RE: Response to Submissions – PA2024/0392
At: Lot 03981 Town of Darwin (17 Harry Chan Avenue, Darwin City)

1.0 Further Information

Via request dated 16 January 2025, Development Assessment Services requested further information to enable assessment of the application to continue. The amended plan set attached hereto addresses the architectural components of the requested further information / clarification. The request items are included in italics below, with the applicant's response to each item contained immediately thereafter.

Figure 1: Public domain space (hatched red)

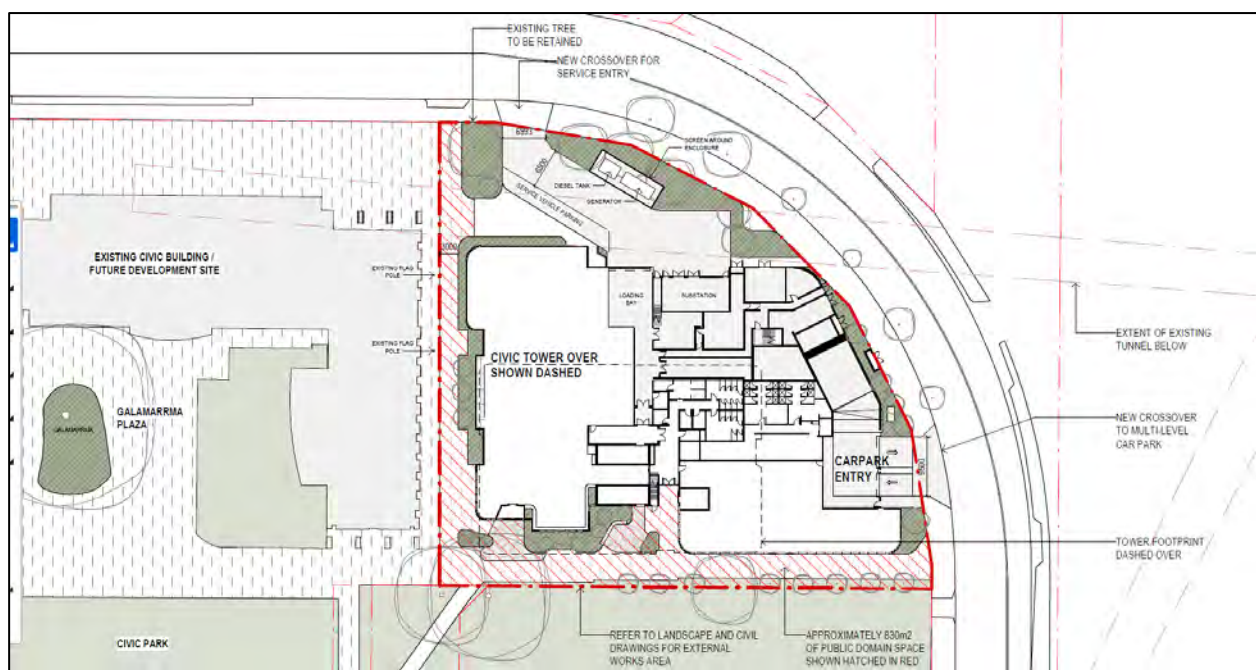
- Provide a written response confirming how the proposed publicly accessible open space meets the requirements of sub-clause 3(a) and 3(b) of Clause 5.9.2.9 Public Domain Contributions for Development on Large Sites.

A total of 830m² public domain space is identified on the architectural plans, equivalent to 17.7% of the development site area. The public domain areas comprise the pedestrian plazas linking Harry Chan Avenue and the Esplanade to the primary building entrance, Civic Park and the future Civic Plaza.

The identified public domain areas do not reflect the full extent of publicly accessible space within the proposed development, rather is limited to the extent that contributes to the public space in accordance with the purpose of **Clause 5.9.2.9**. The identified public domain space incorporates shading from the building awnings, lighting and landscaping (together with additional landscaping in other areas of the development) and provides sufficient space and opportunities for park furniture and art installations.

2248_DA DA-001 Rev 5 22/01/2025 11:31:26 AM
Drawn: JH Check: CA AMENDED DA ISSUE

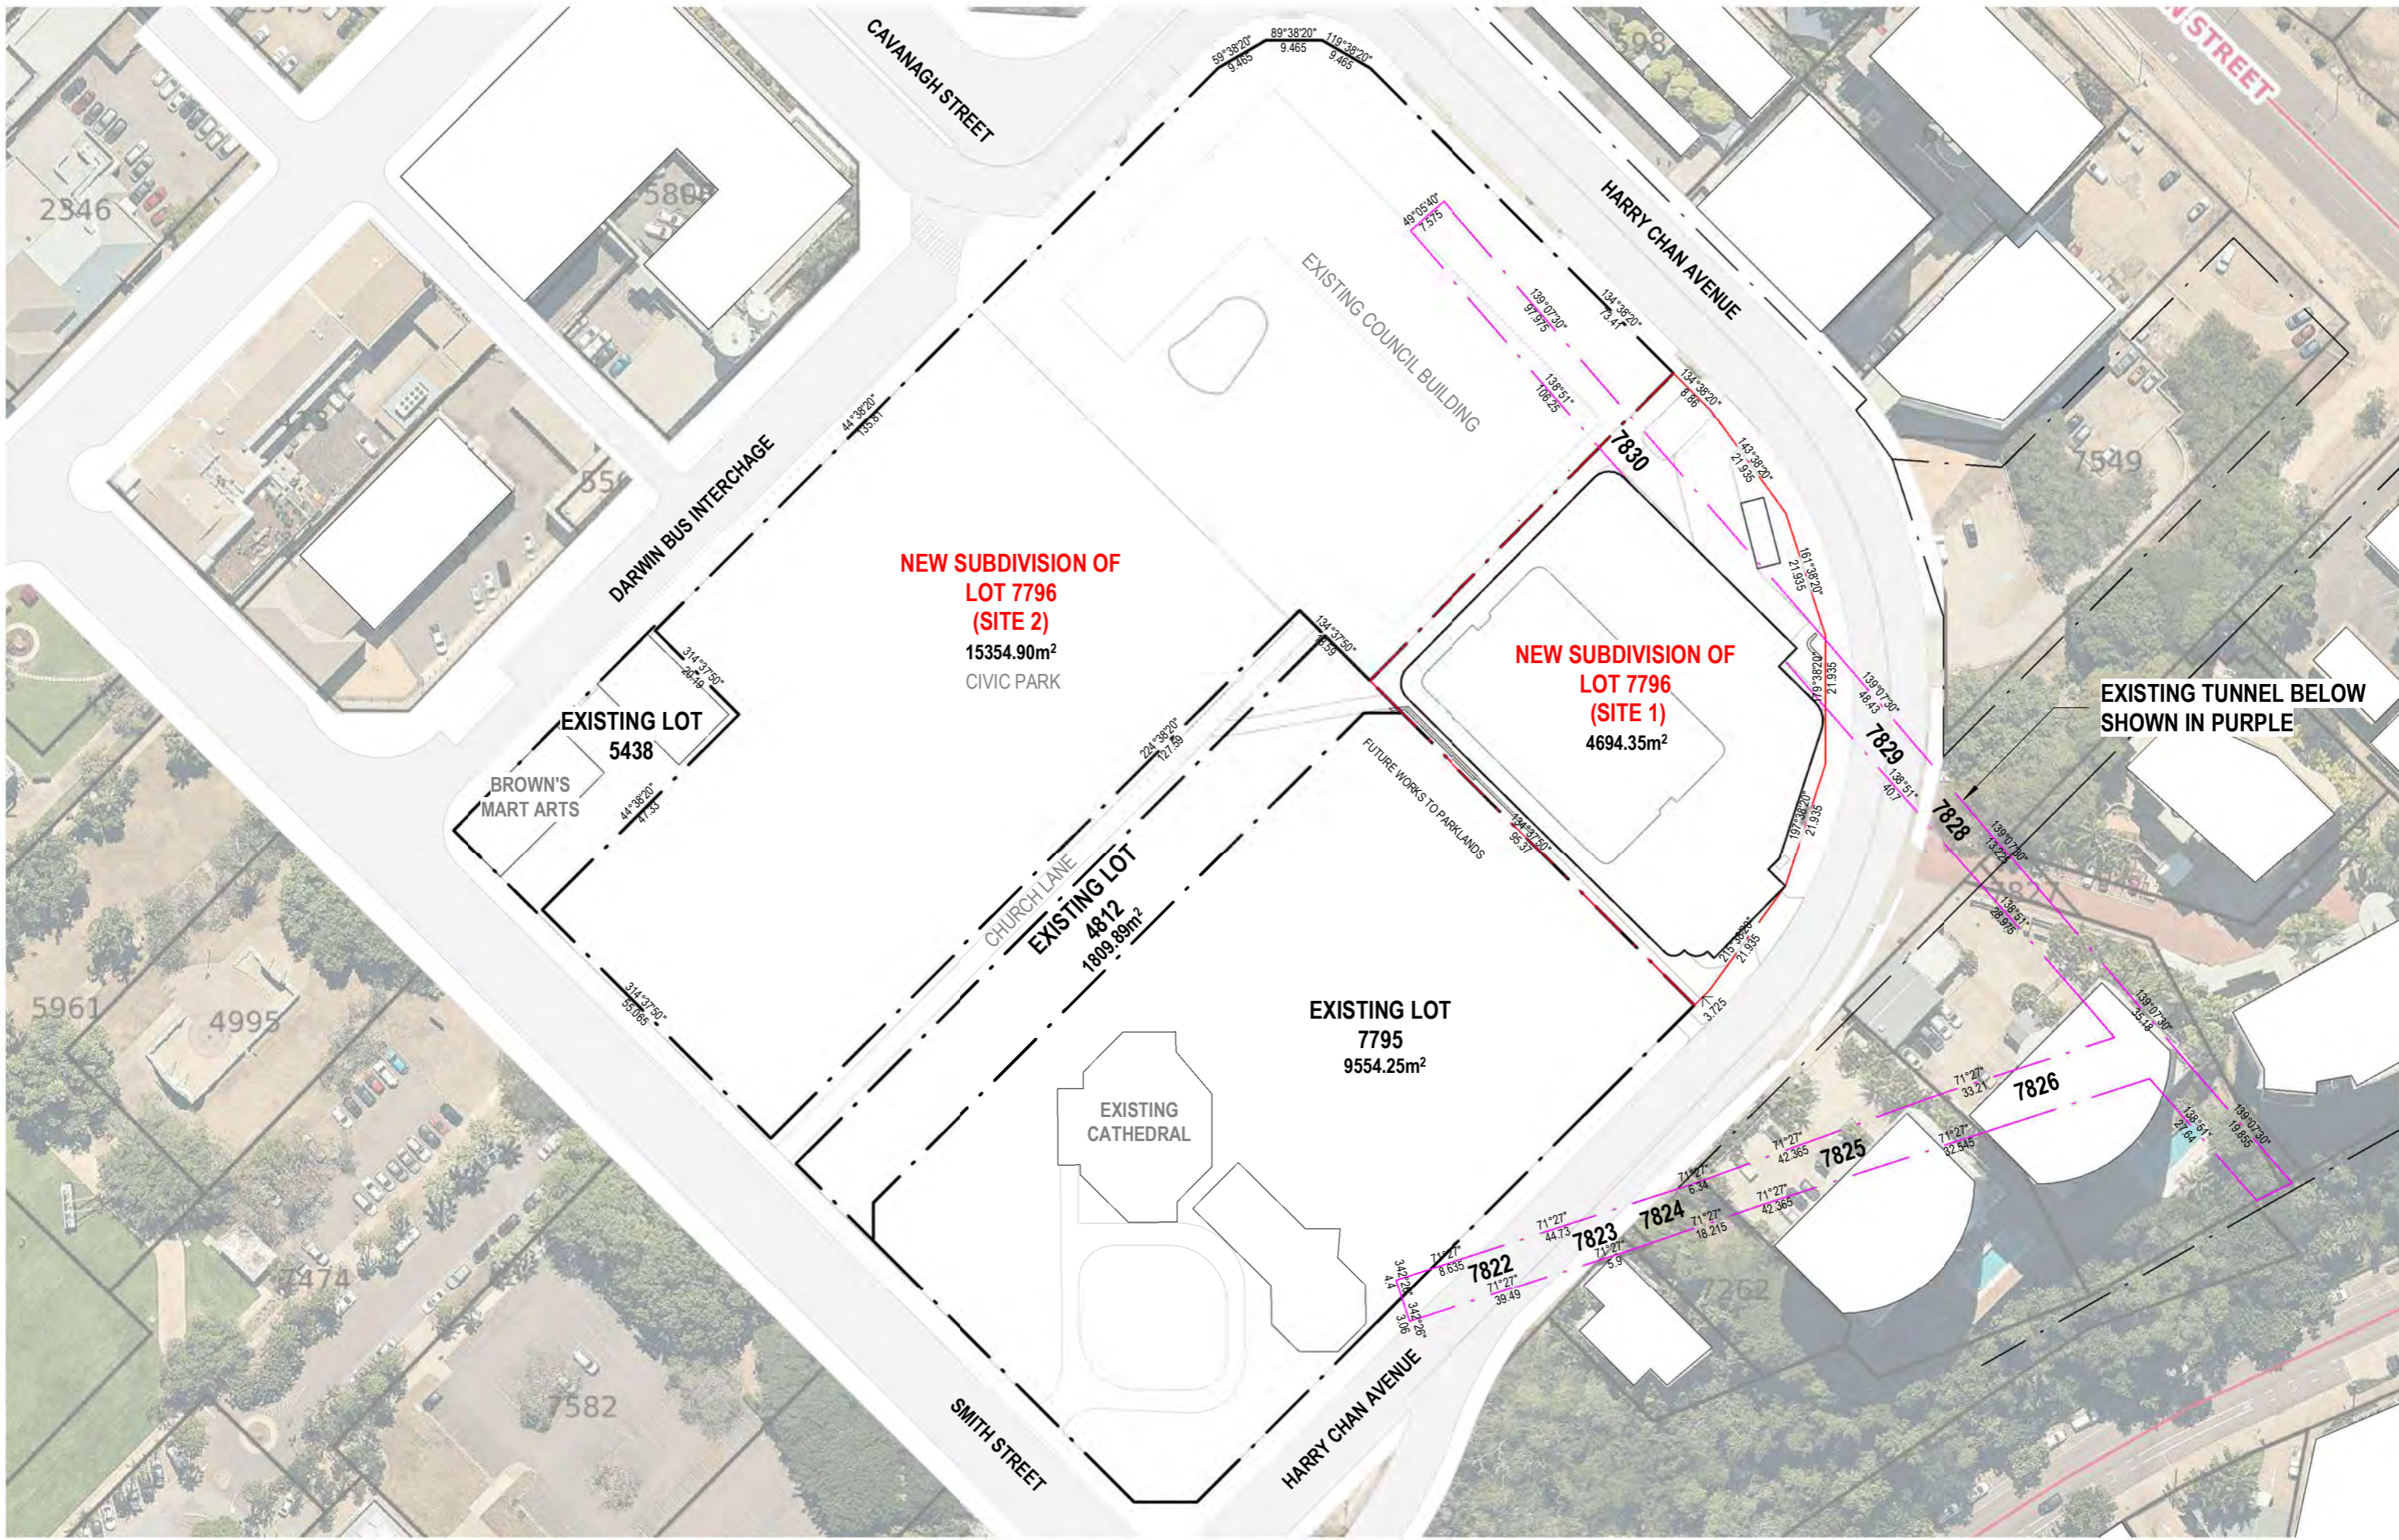
- *clarify if the sqm area table on drawing DA-001 is correct (noting that 2 different areas are identified).*

The table on DA-001 has been corrected to clarify the collective planting area within the proposed development at 757.5m², equivalent to approximately 16% of the total development area.

2248_DA DA-101 Rev 4 22/01/2025 11:32:53 AM
Drawn: FT Check: JH **AMENDED DA ISSUE**

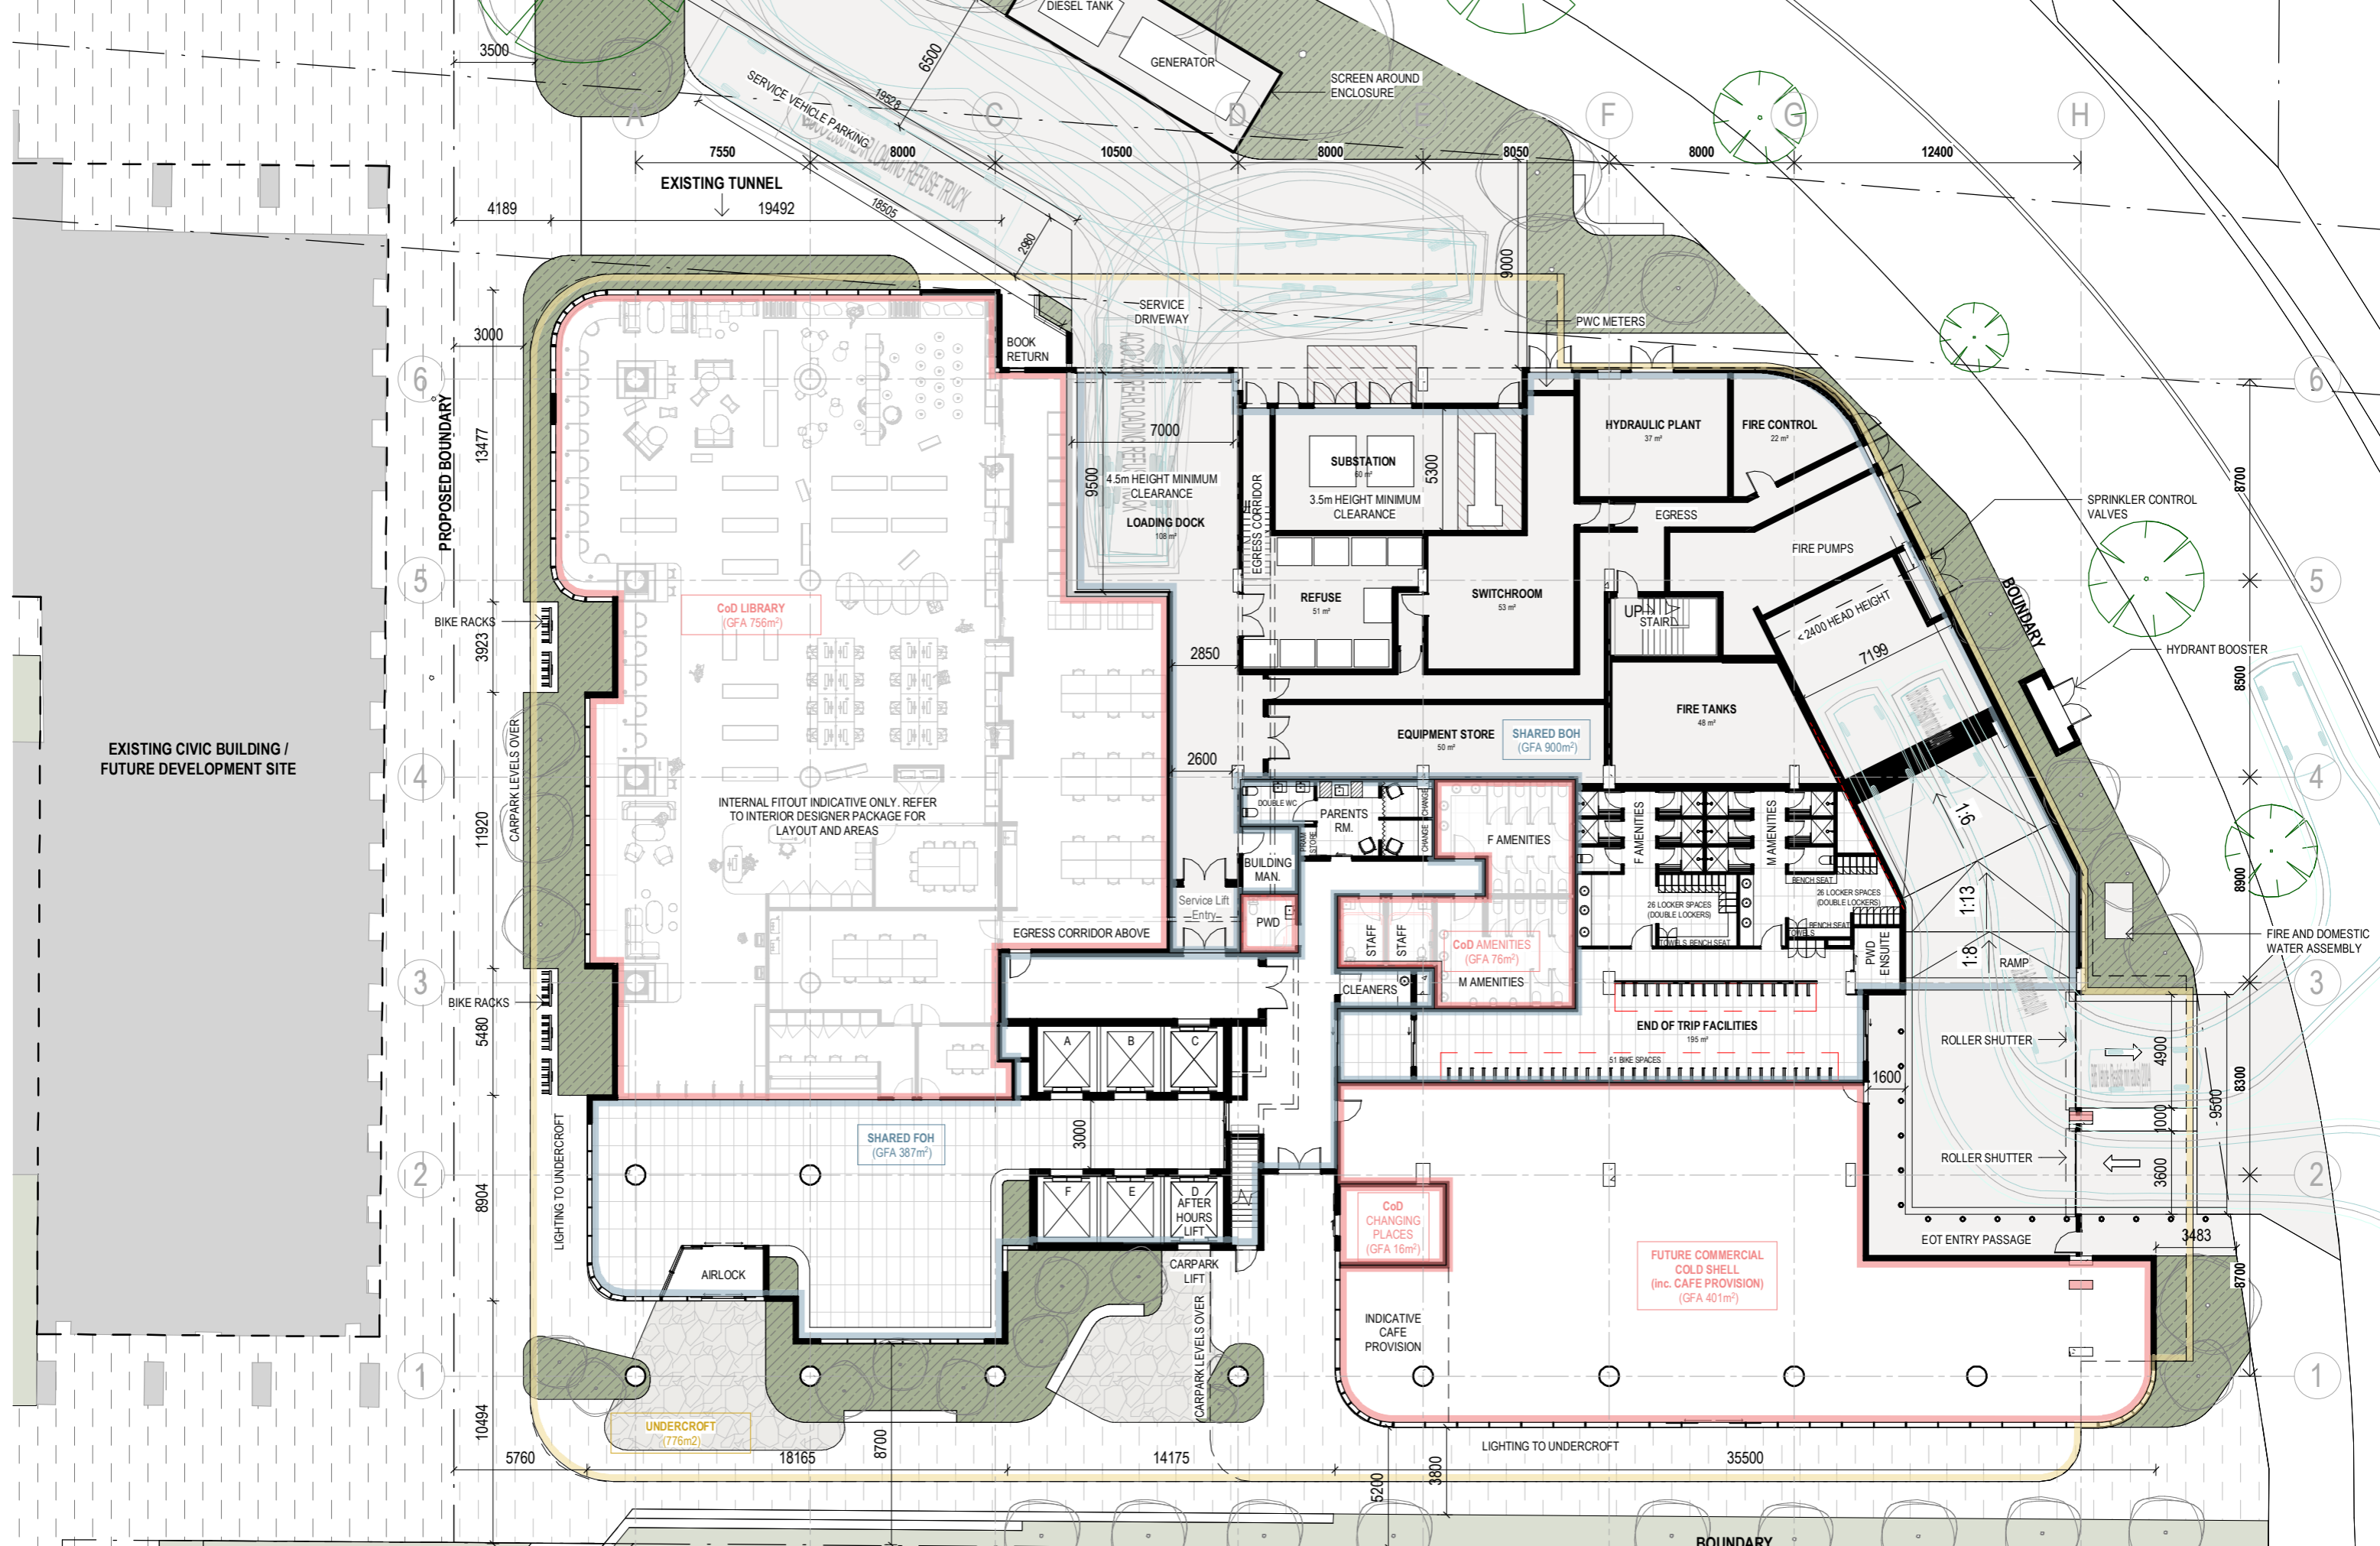
- *Update drawing DA-101 to show:*
 - *the entire site (noting that on the exhibited documents the northern corner is cut off from the plans).*

The full boundary extent of the development site shown in DA-003.
